DESIGN REVIEW COMMITTEE

September 20, 2023 6:00 PM

AGENDA

2
C-I
EXISTING SITE
SCALE: 1" = 20'

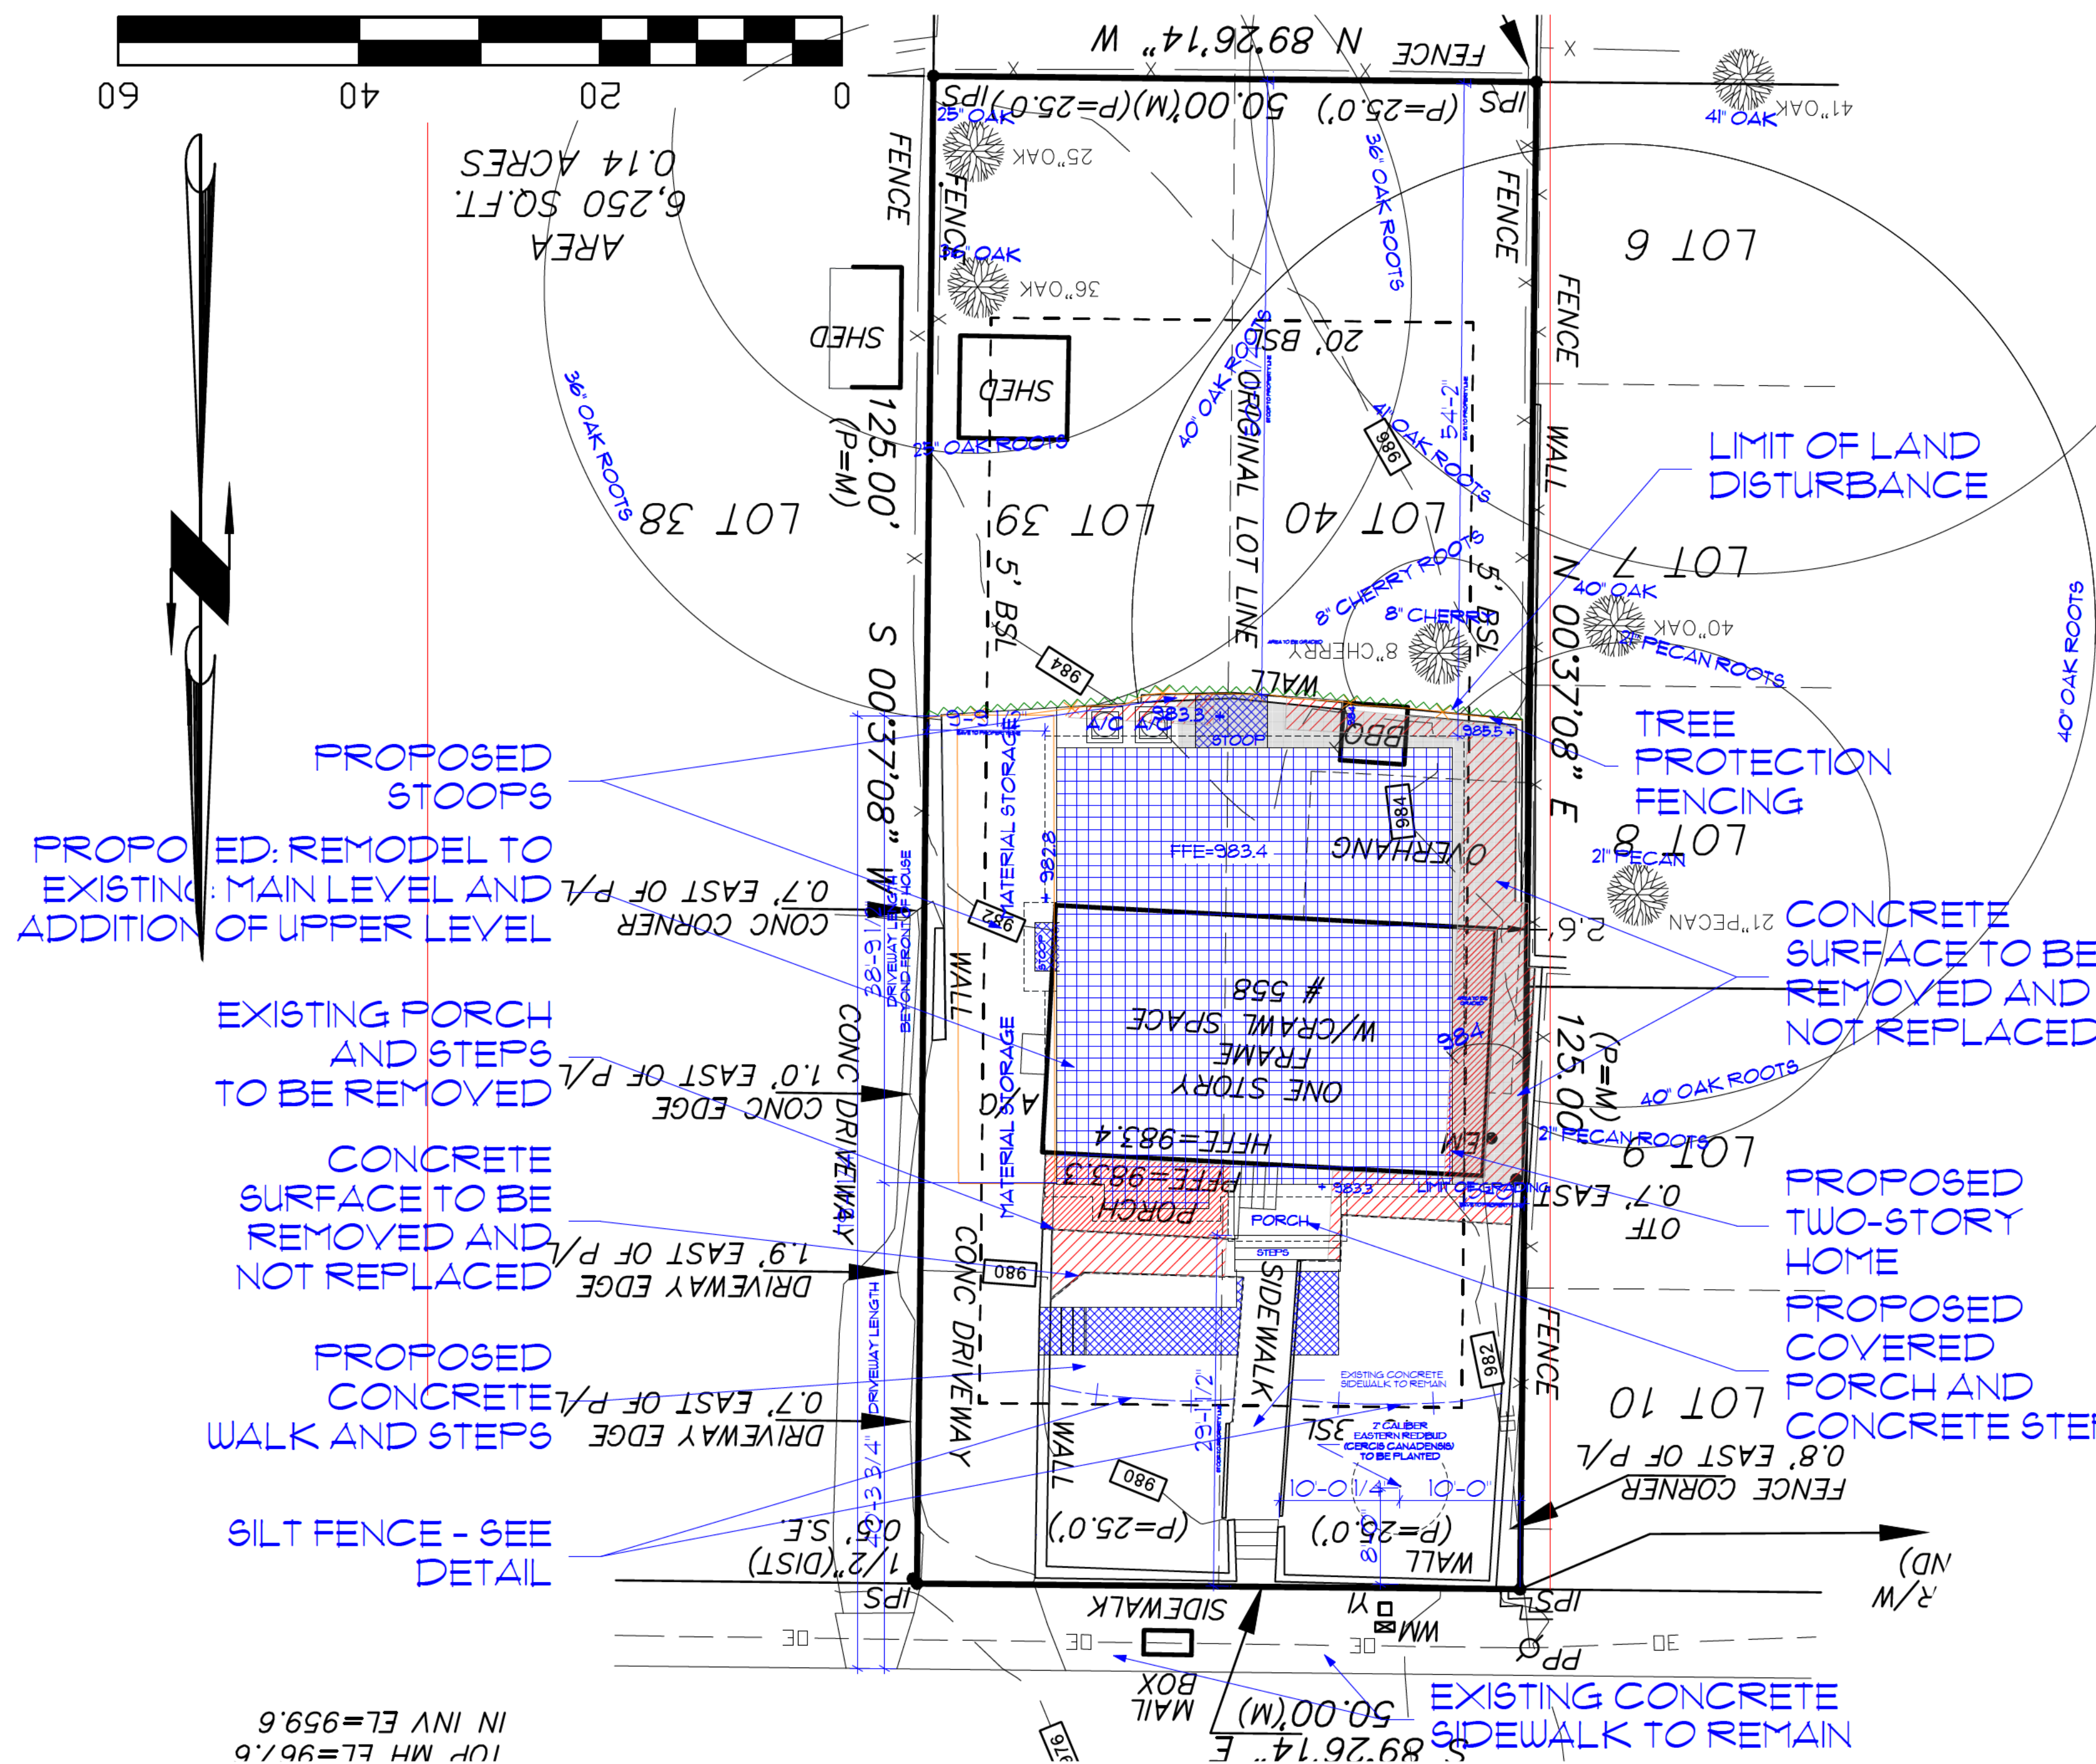
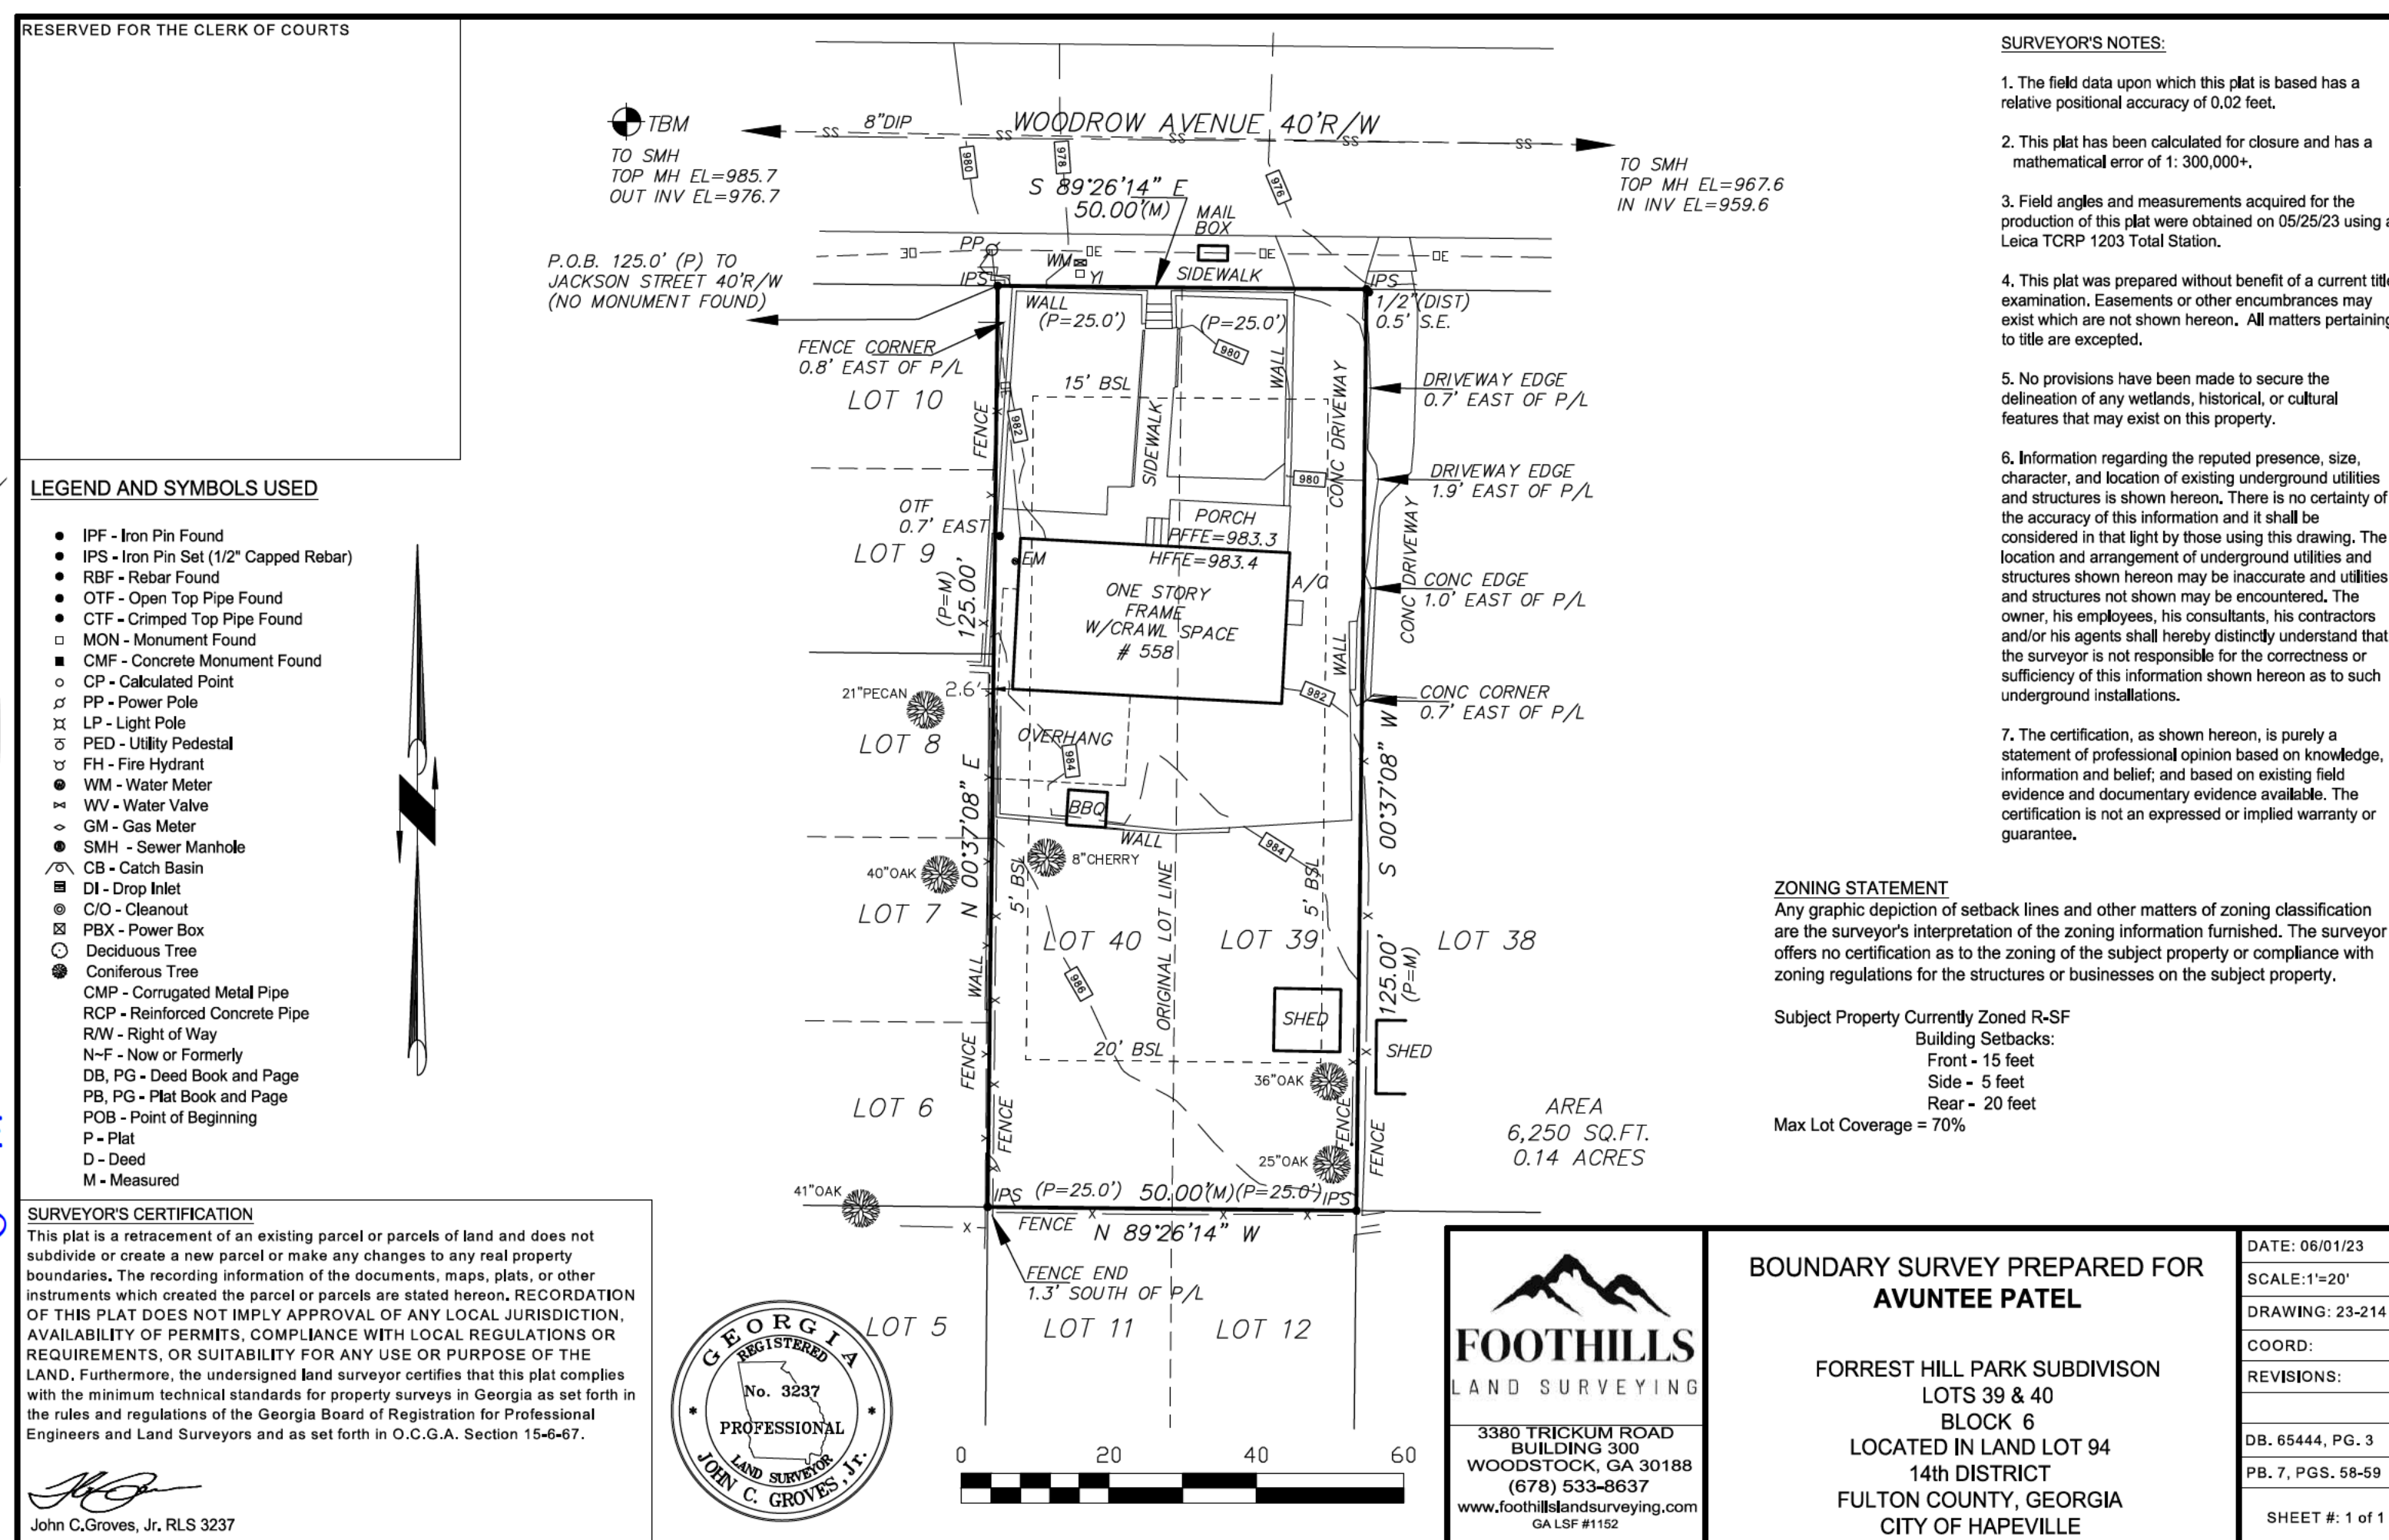
STAFF COMMENT: Tree Conservation Plan to be finalized with Arborist. Tree required in front yard. Chain link fence existing along north side. Applicant indicated at Planning Commission the fence would be removed.

- Show mechanical on plans. MUST be screened.
- Finalize and obtain Tree Conservation Plan approval by Arborist.
- Provide a tree in front yard sized per Tree Conservation Plan requirements.
